Subject: Comments to Project Title "Pacific Gas and Electric Company (PG&E) Line
406-407 Natural Gas Pipeline (SCH No. 2007062091)

**Re: CSLC EIR No. 740 (State Clearinghouse No. 2007062091) for PG&E
Line 406 and Line 407 Pipeline Project Land Use Compatibility with
Respect to the Sierra Vista Specific Plan**

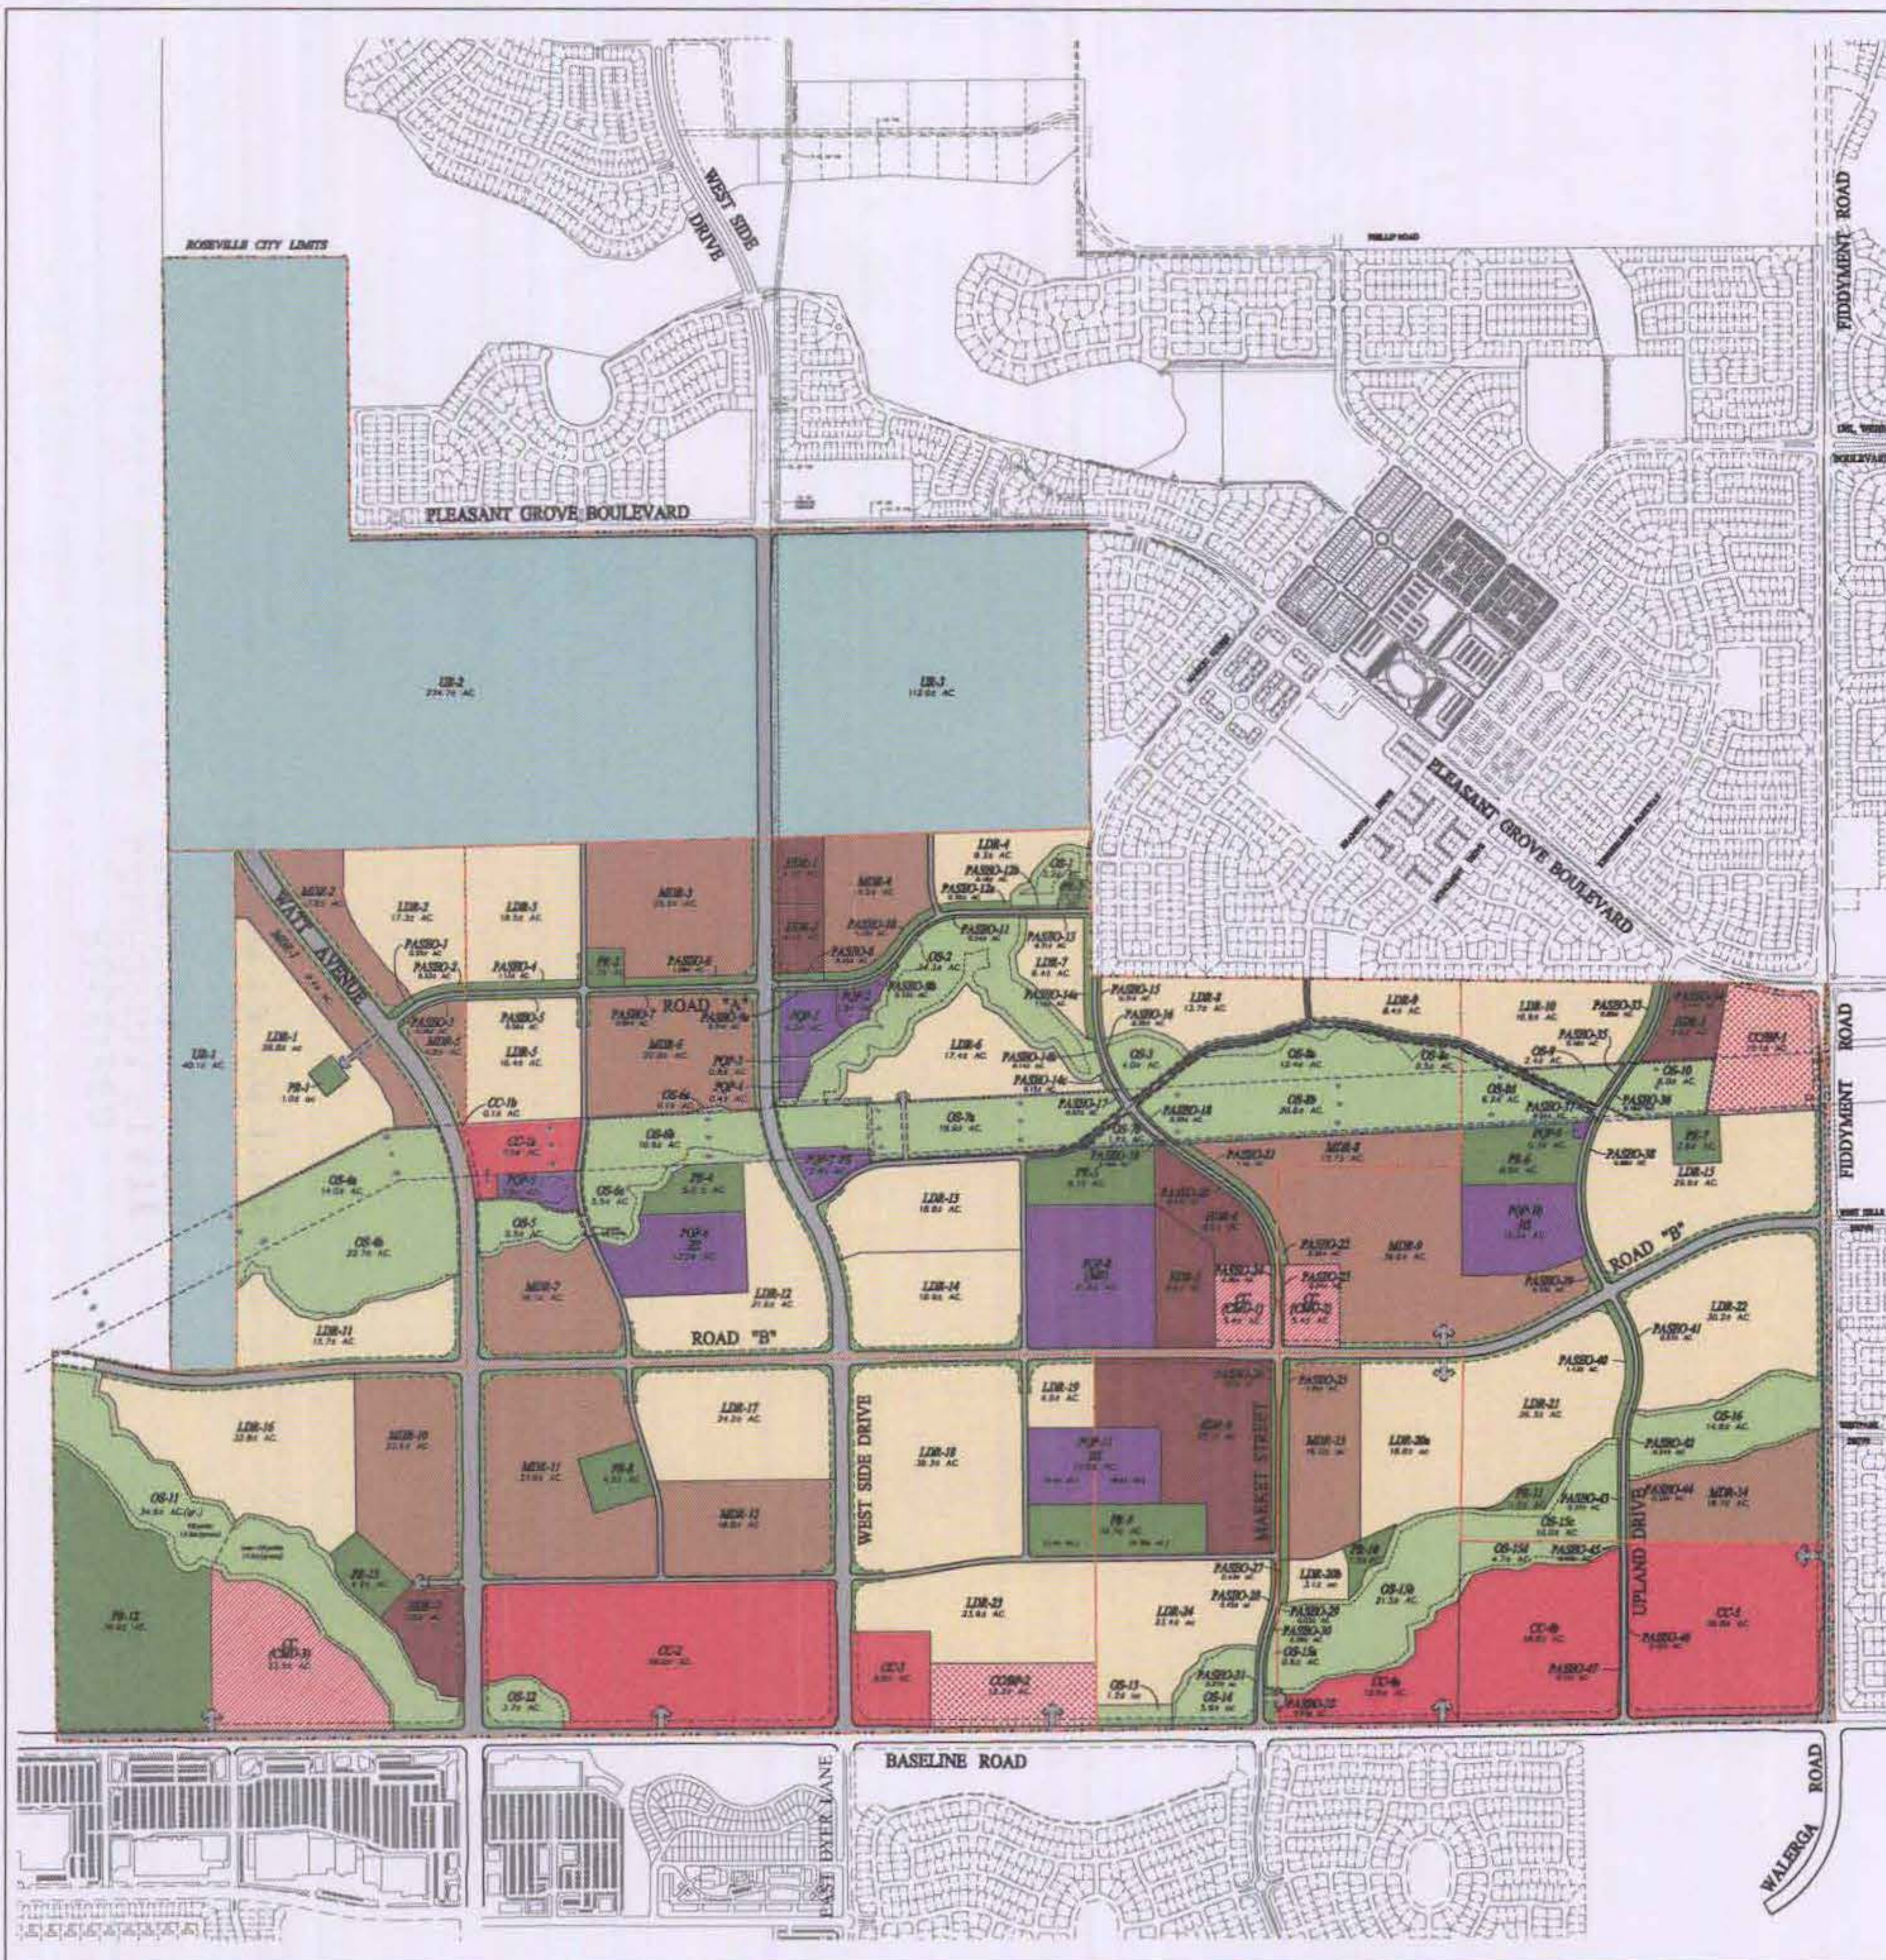
We are requesting that the ultimate design of the Line 407 Project address the above-described concerns. In addition, in order to minimize the risk of the potentially hazardous facility and to reduce the risk of potential future conflicts we are requesting the following modifications to the Line 407 Project:

In summary, the attached land plan represents the culmination of a long process of careful land use planning and engineering work, in which PG&E has not actively participated. At this point, the Commission's review of the Line 407 Project in the DEIR must take into account the school sites and other sensitive land uses that are planned within Sierra Vista near the Baseline Road frontage. The requisite easements, clearances, and potential conflicts associated with the pipeline cannot be identified until the ultimate right-of-way for Baseline Road has been determined. It is apparent that greater consultation between the Commission and the City regarding potential land use conflicts is in order.

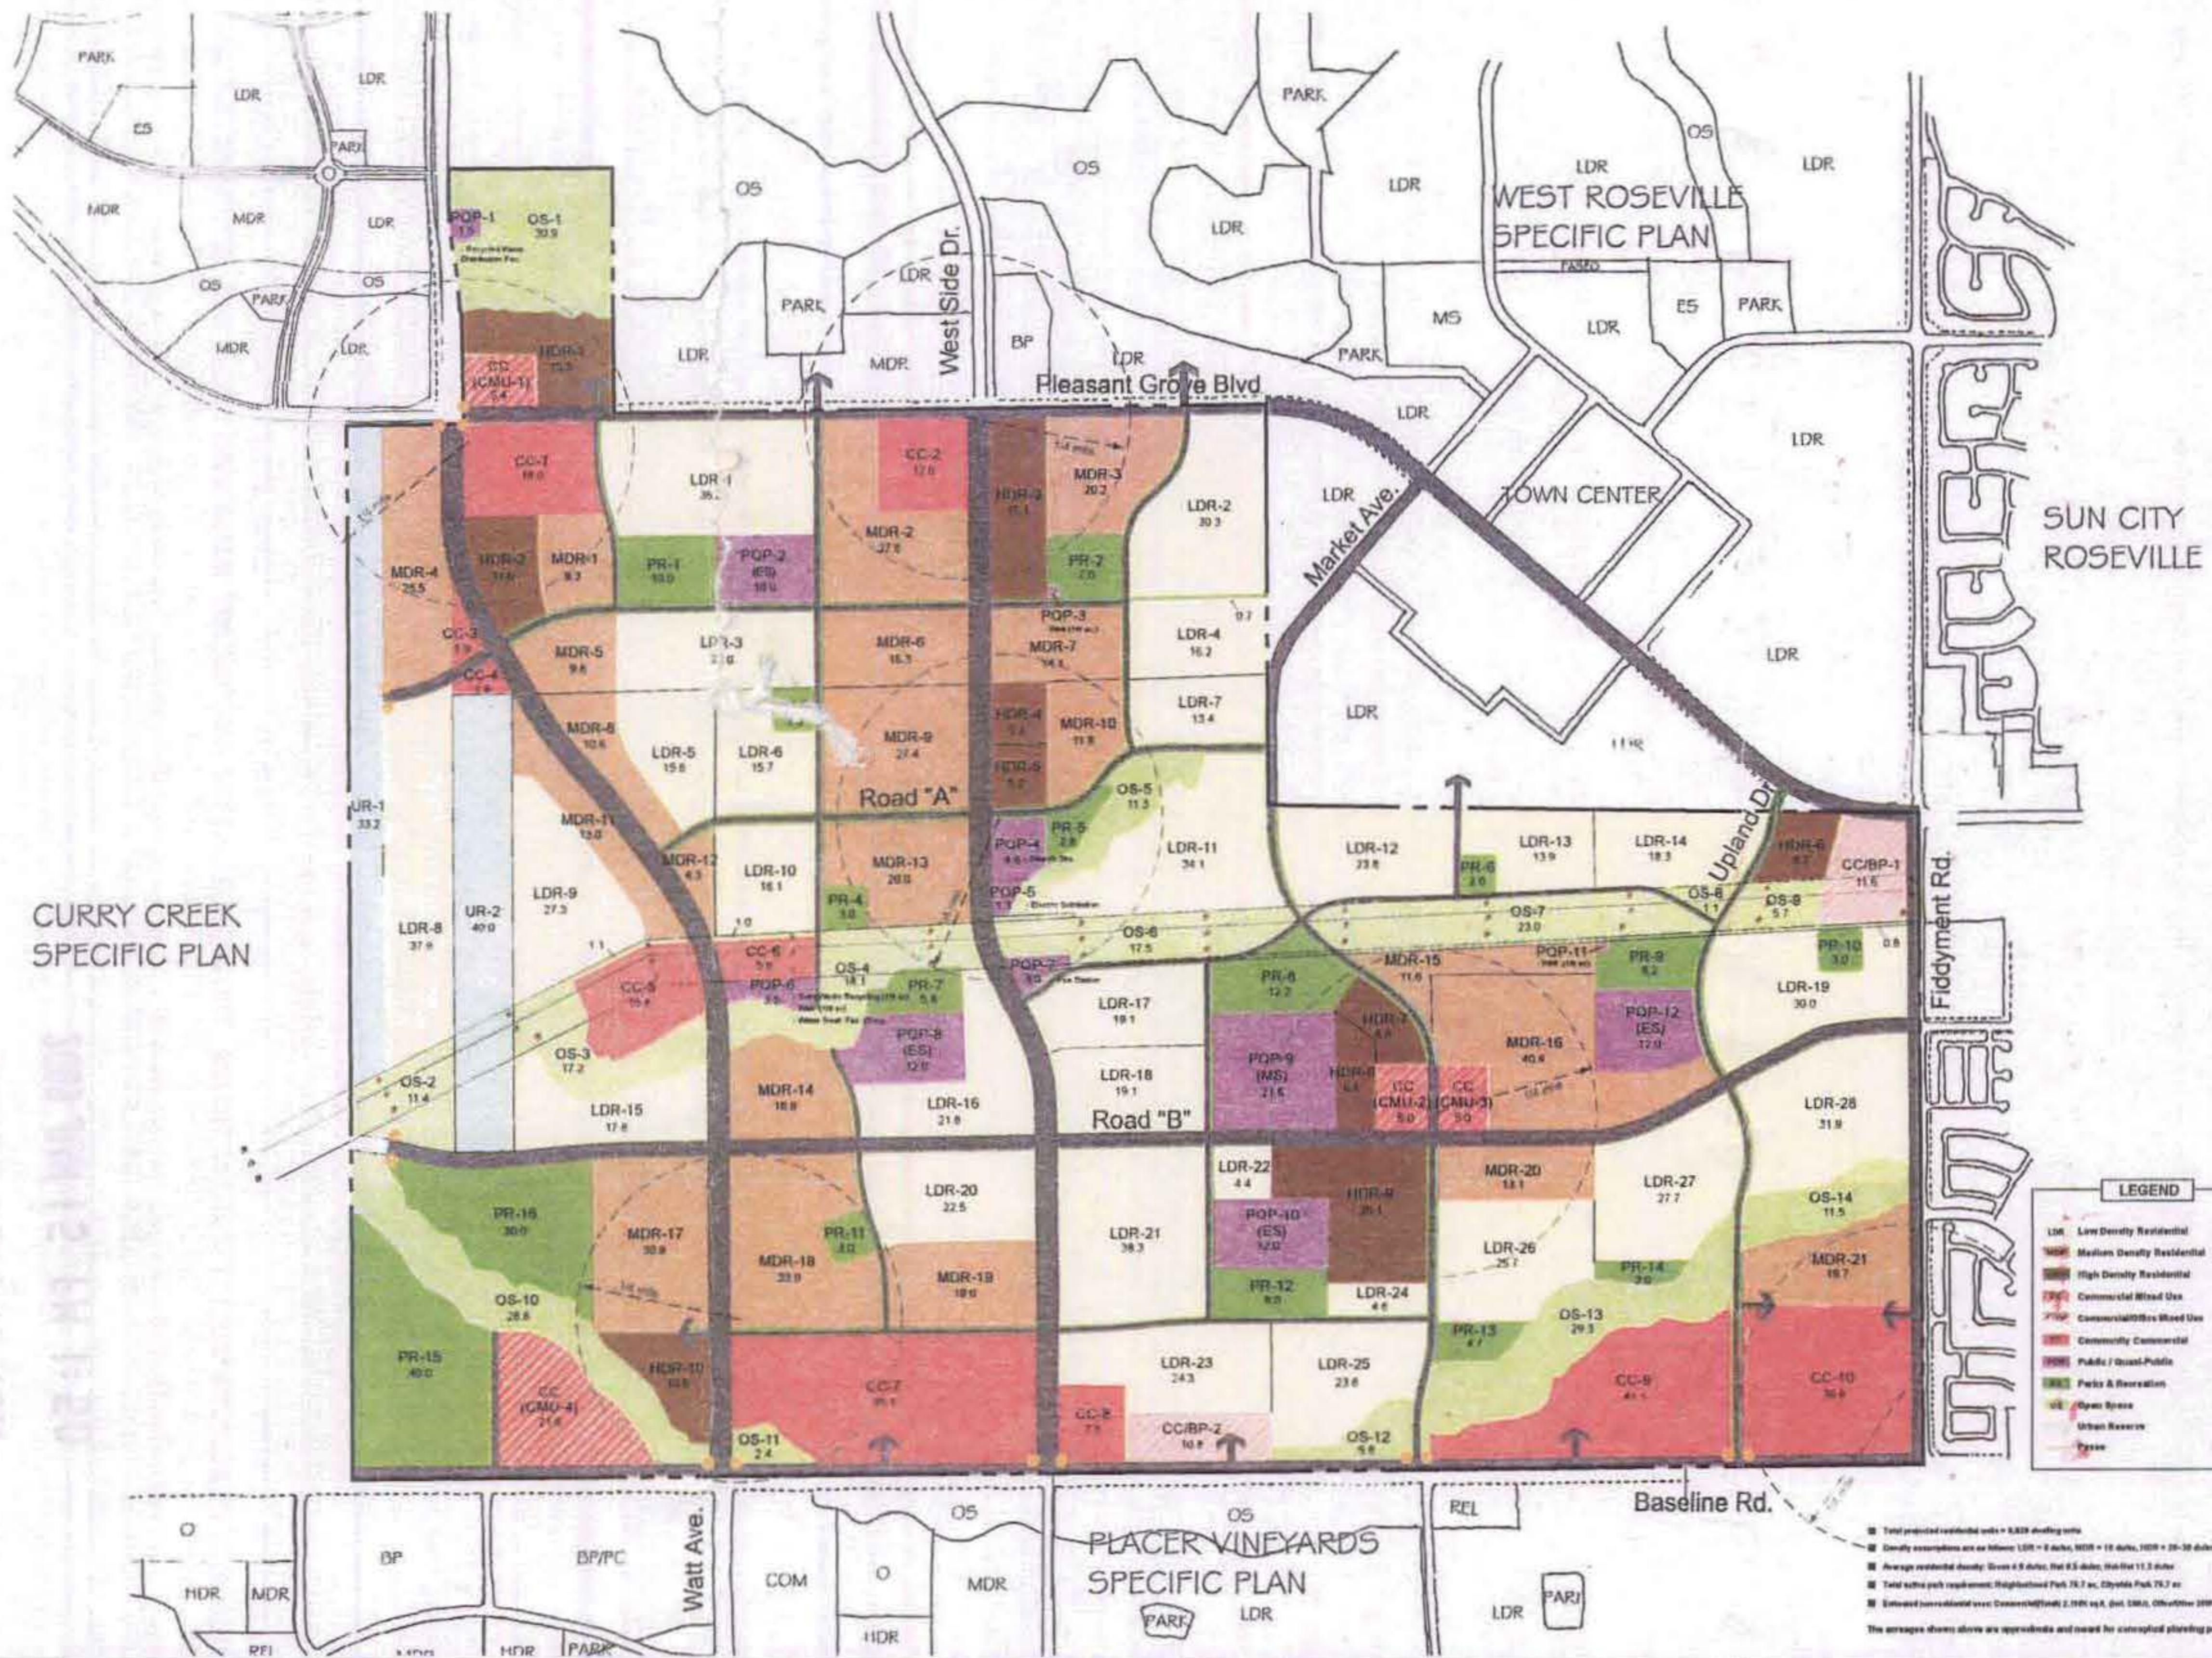
- The proposed location of the Baseline Road Pressure Regulating Station (PRS) conflicts with SVSP parcel CC-10. Parcel CC-10 is planned to be a regional shopping center. The City requests that the Baseline Road PRS be relocated westerly to future SVSP parcel OS-13 or other acceptable location (see attached land use plan). At the June 5th meeting it was agreed that SVSP land owner consultants would provide additional information related to this proposed relocation and that PG&E would further evaluate the proposal in relation to proposed HDD work and resource issues. In a subsequent email to the City PG&E indicated that there is some limited potential for adjusting the location of the station but there are issues that need to be addressed before the final location can be confirmed and that PGE is willing to work with the City of Roseville and the Sierra Vista developers to locate a mutually acceptable location once the design parameters firm up. The City looks forward to working closely with PG&E on this issue.

- The proposed underground cluster valve station was also discussed at the June 5th meeting. It was agreed that the City and PG&E would work together to locate this feature so that it is compatible with specific plan development.
